Technical Bulletins Sorted By Bulletin Number
Generated 12/31/92

BULLETIN NO.: I/O:02

PRODUCT: 26-1171 Telephone Interface II

Figure 1

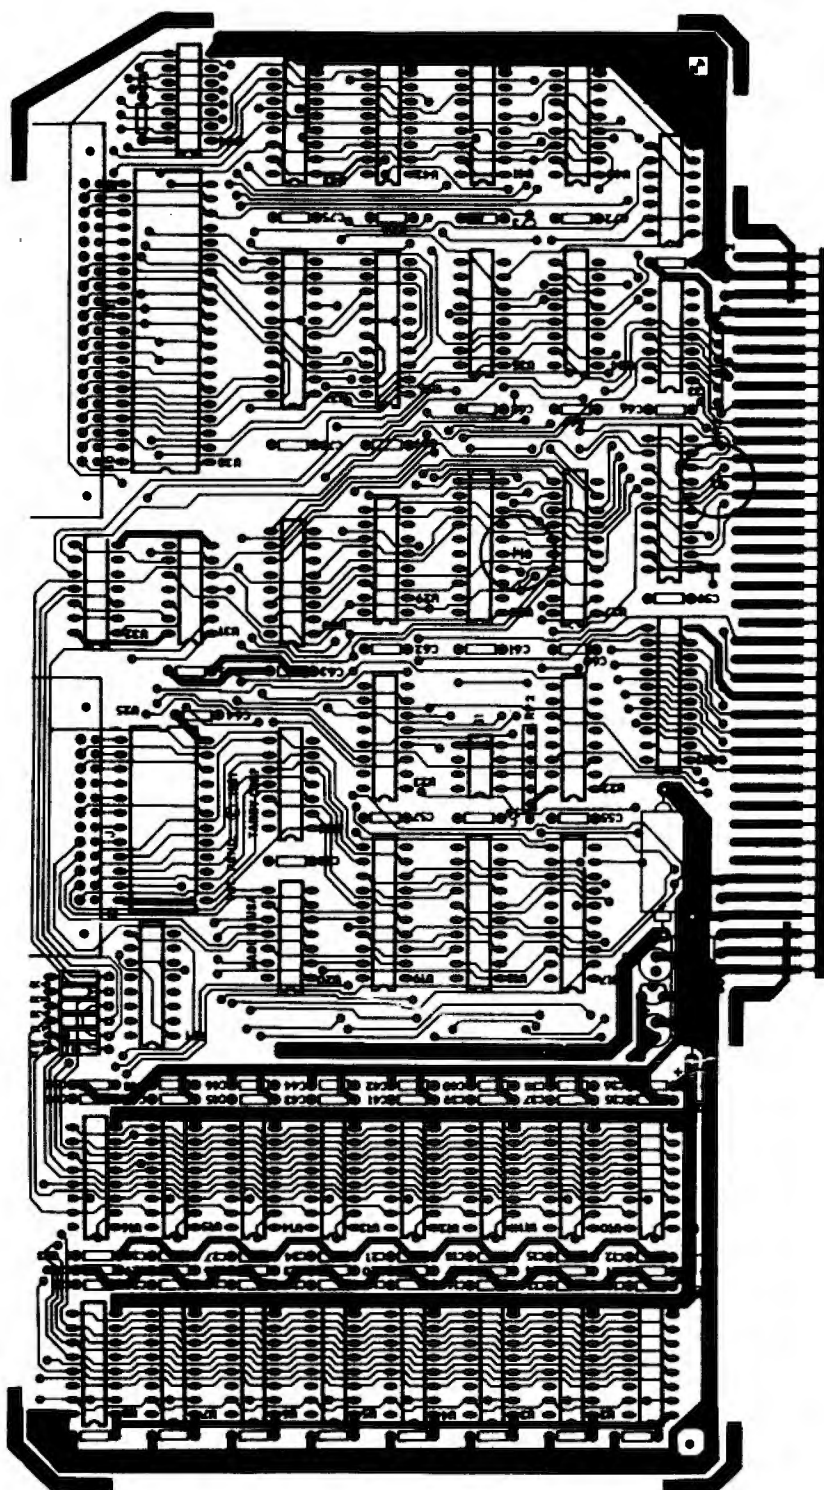
Cuts: U26 pin 6 (pin 26 on the edge card connector)
(See figure 1) U28 pin 5 (cut at the first feed through)

Jumpers	U38 pin 39	to	U32 pin 4
	U38 pin 40	to	U32 pin 5
	U32 pin 6	to	U26 pin 6
	U26 pin 14	to	U28 pin 5

Schematic Revision
Figure 1

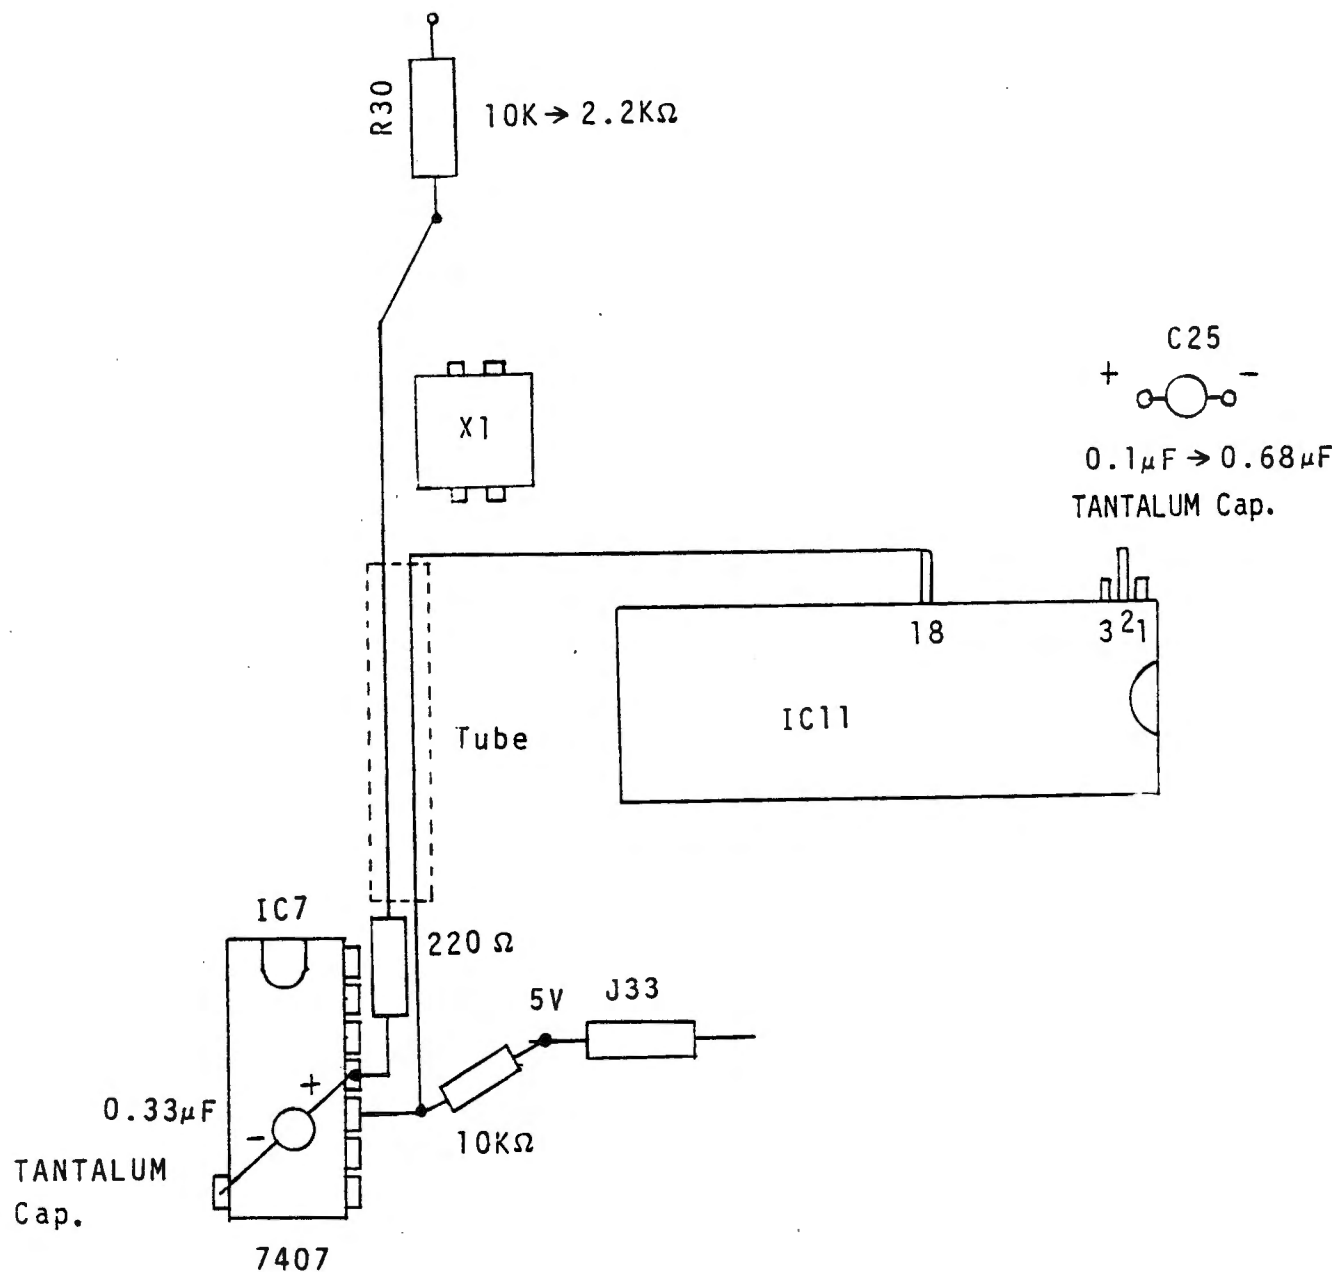
PROCEDURE: To correct this problem perform the following modification (Refer to Figure 1 for schematic revision and Figure 2 for component layout):

- 1) Cut trace right at IC11 (CPU) pin 18 (Refer to Figure 3).
- 2) Change R3Ø from 1ØK ohm to 2.2K ohm 5% 1/4 watt.
- 3) A. Add a 22Ø ohm 5% 1/4 watt resistor at pin 11 of IC7.
B. Add a jumper from the other end of this 22Ø ohm resistor to R3Ø.
This jumper should be added to the end of R3Ø that goes to IC11 pin 11 not the +5V side.
C. Use a piece of vinyl tubing (shrink) around the junction of the 22Ø ohm resistor and the added jumper connecting the 22Ø ohm resistor and R3Ø to prevent shorting.
- 4) Add a 1ØK ohm 5% 1/4 watt resistor between pin 1Ø of IC7 and J33.
- 5) Add a jumper from pin 1Ø of IC7 to pin 18 of IC11.
- 6) Add a .33ufd capacitor (35V 1Ø% Tantalum) with the positive lead (marked by a + or dot) going to IC7 pin 11 and the negative lead going to IC7 pin 7.
- 7) Change C25 from a .1ufd capacitor to a .68ufd capacitor (35V 1Ø% Tantalum).

FIGURE 3
PCB CHANGES

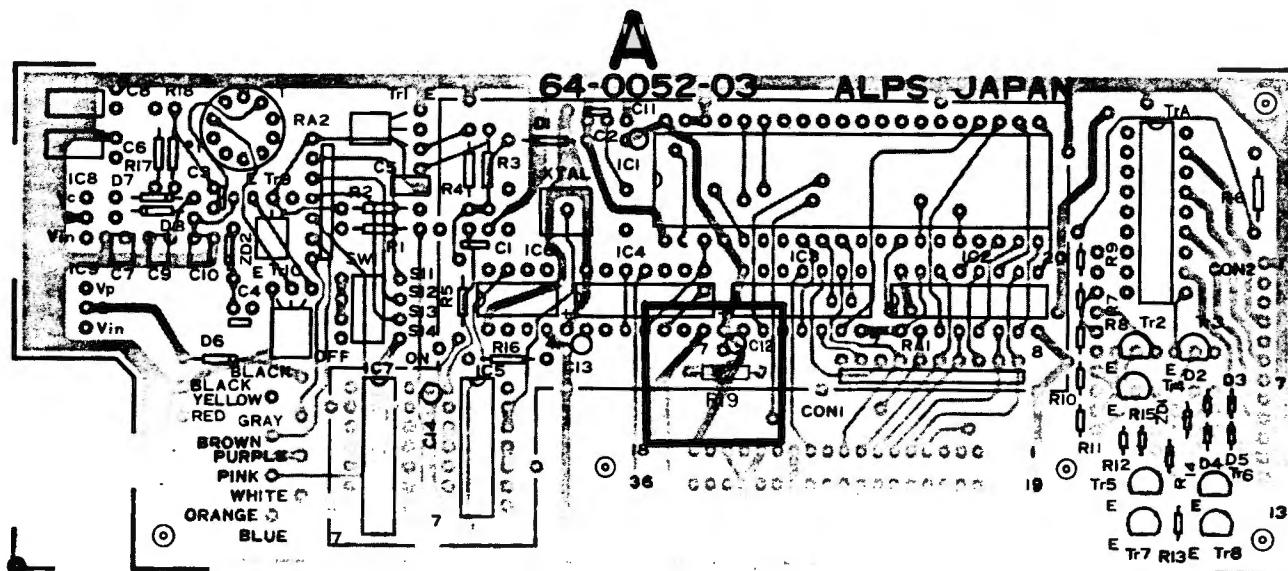
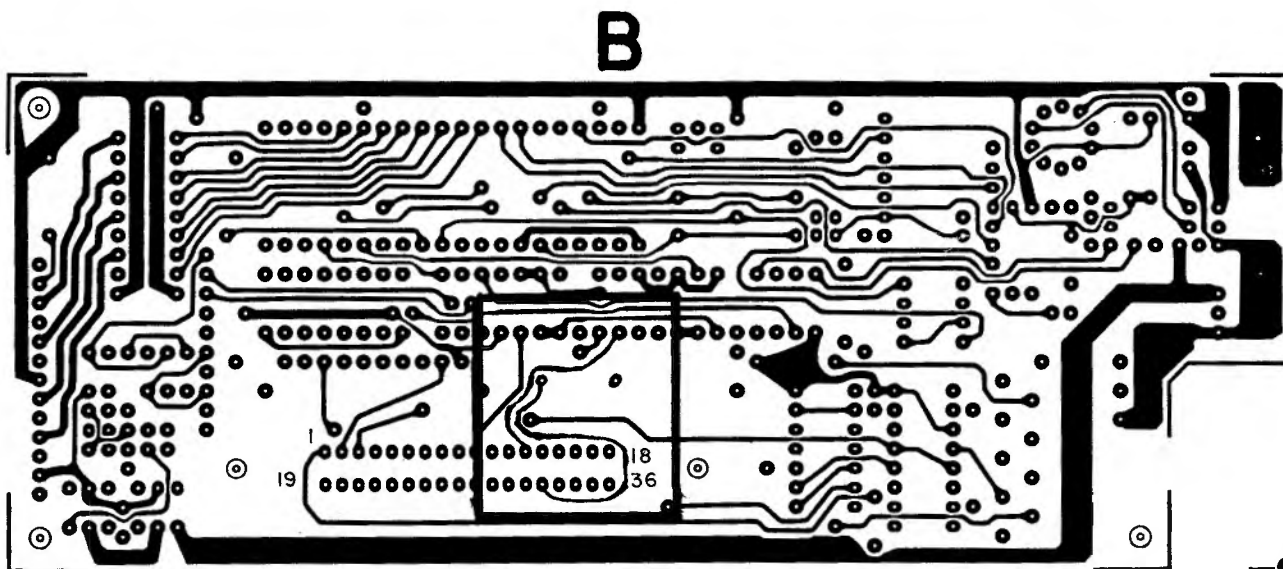
Figure 3A and 3B show the changes to the PCB layout. On the TOP view, note the addition of R19, located between C12 and CON1. On the BOTTOM view, note the addition of two traces. One connects to CON1 pin 13, the other connects to CON1 pin 32.

Figure 1

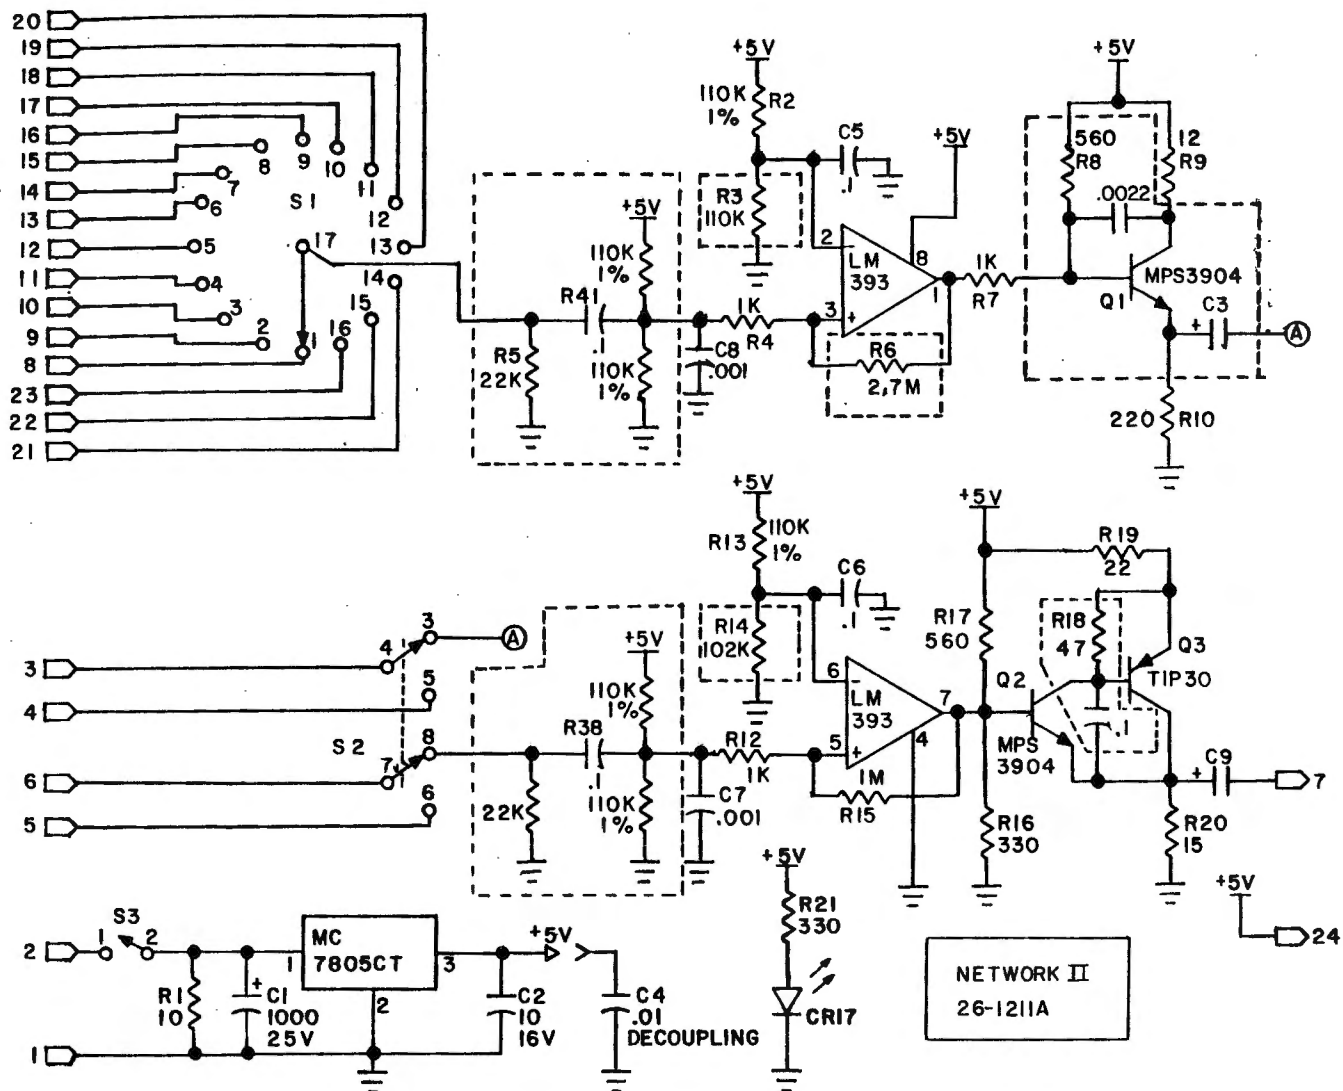
PROCEDURE: This procedure involves removing, adding, and changing several parts. Refer to the new schematic, figure 1, to double check the positions of the new parts. The areas within the hash marks reflect the changed or added parts.

- A. Add a 110K 1/4w 1% resistor from the junction of C7 and R12 to +5 volts.
- B. Add a 110K 1/4w 1% resistor from the junction of C7 and R12 to Ground.
- C. Add a 110K 1/4w 1% resistor from the junction of C8 and R4 to +5 volts.
- D. Add a 110K 1/4w 1% resistor from the junction of C8 and R4 to Ground.
- E. Add a 22K 1/4w 5% resistor from the junction of R38 (now a .1 mfd capacitor) and wire #8 of the MPLX-CASS switch to Ground.
- F. Add a .0022 mfd capacitor from the junction of R8 and Q1 Base to the junction of R9 and Q1 Collector.
- G. Add a .1 mfd capacitor from the Base of Q3 to the Collector of Q3.

FIGURE 1

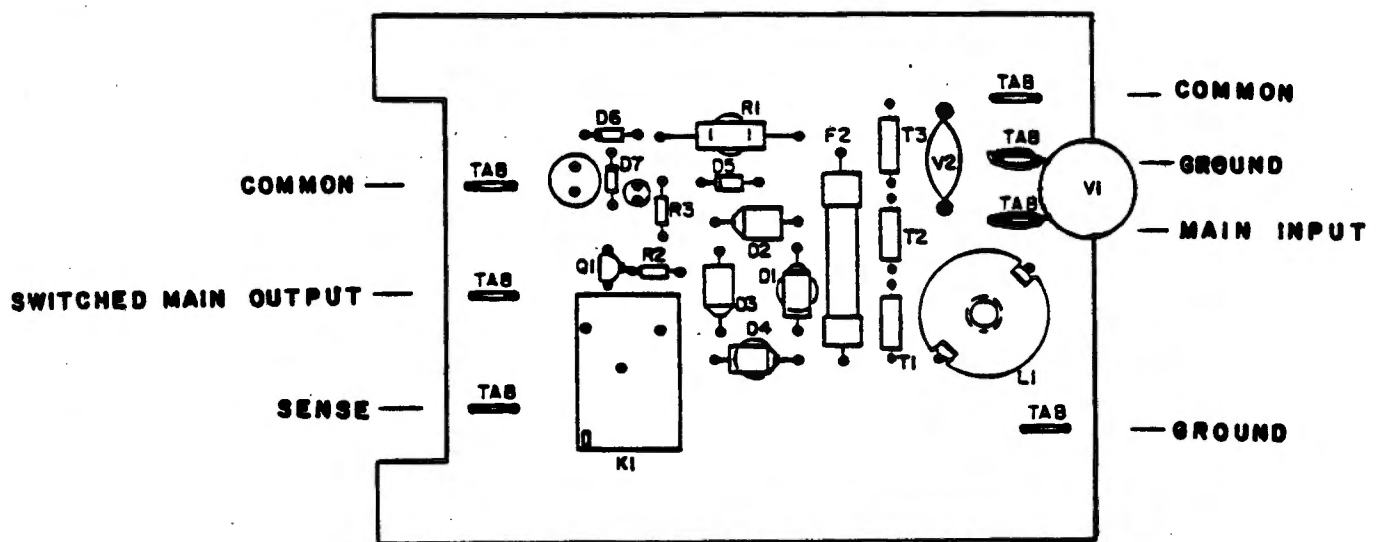
- 1) Remove the original Transient Suppressors V1 and V2 from the PC board.
- 2) Install the new V2, S20K130, in the two holes vacated by removing V1 and V2. Take great care that the leads of V2 do not touch the GROUND tab. Use short pieces of insulating tubing if necessary. See Figure 1.
- 3) Install the new V1, S14K130, between the GROUND tab and the MAIN INPUT tab. Make sure that the leads are mechanically secure and as short as possible. Attach the leads as close to the circuit board as possible so that the push on connectors are not obstructed. See Figure 1.

Figure 1 Component Layout

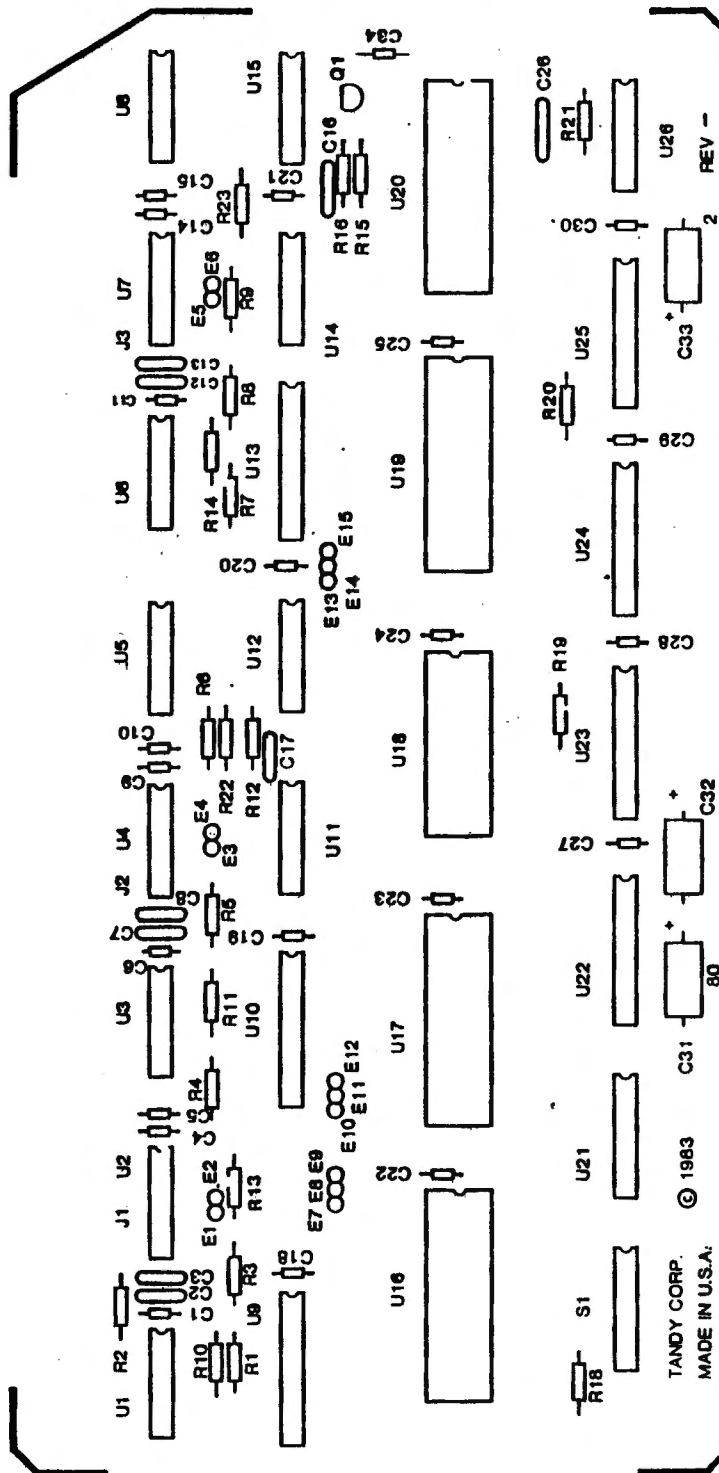
Figure 1 is the component layout of a REV - or revision blank PCB. The problem with REV 1 PCB's only involves R13 and R21. Referring to Figure 1, R21 is located just above U26 and R13 (silk screen only, a resistor is not there) is located just below U2. On REV 1 boards the resistor located above U26 is missing and the resistor that's below U2 is incorrectly labeled R21. This resistor should be labeled R13.

Figure 2 Circuit Trace (solder side)

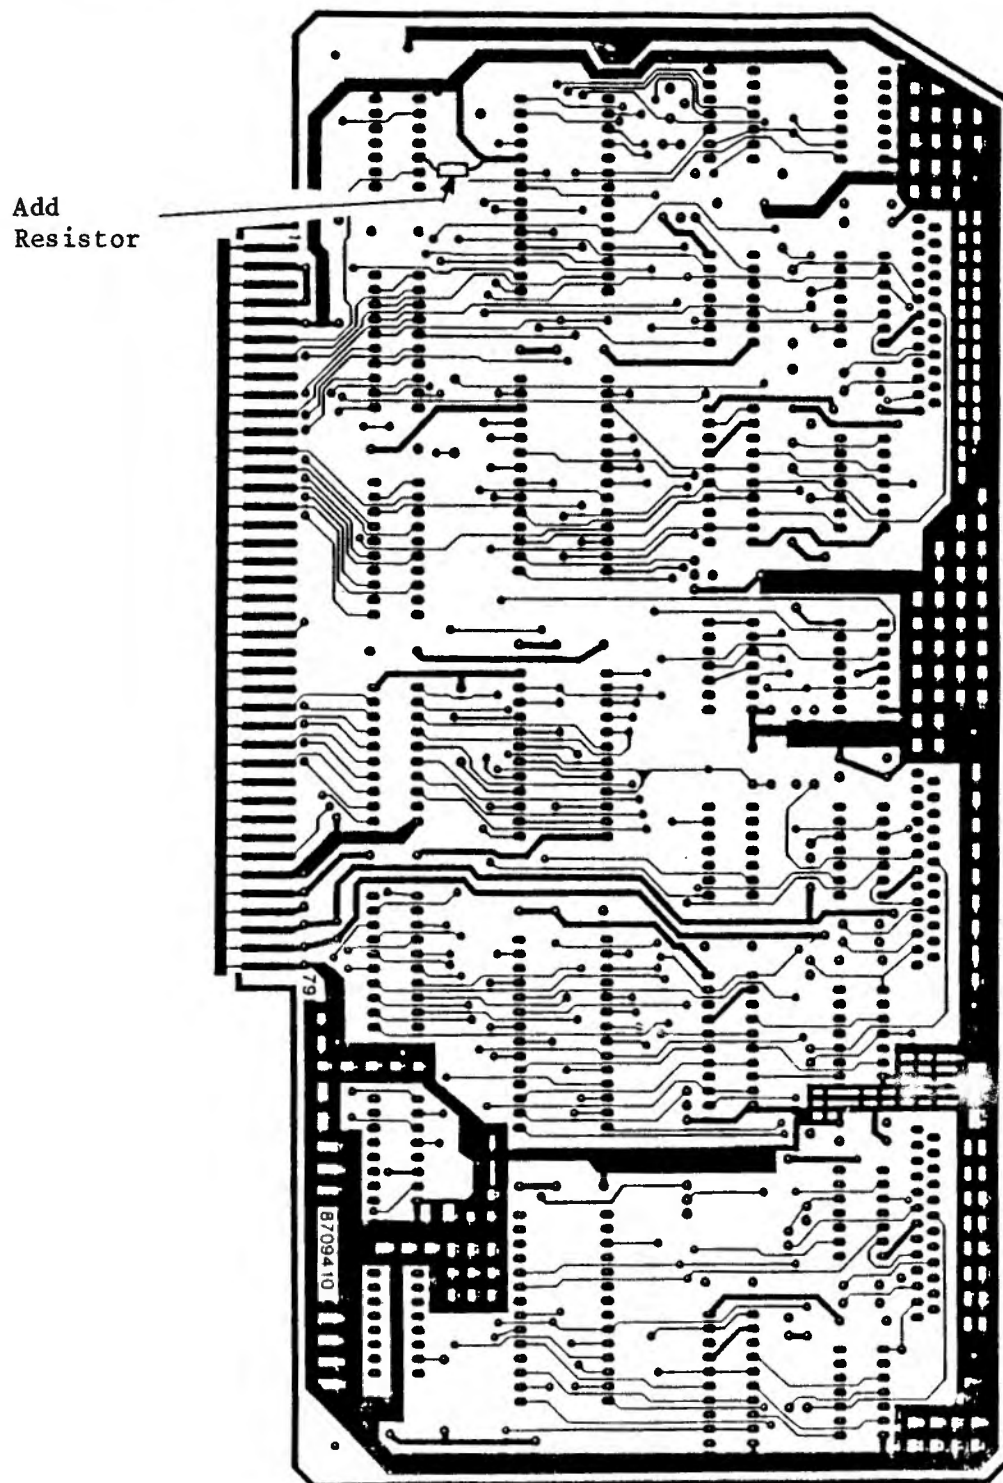
Refer to Figure 2 and add a 4.7K ohm 1/4 watt pull-up resistor from pin 5 of U26 to +5 volts.
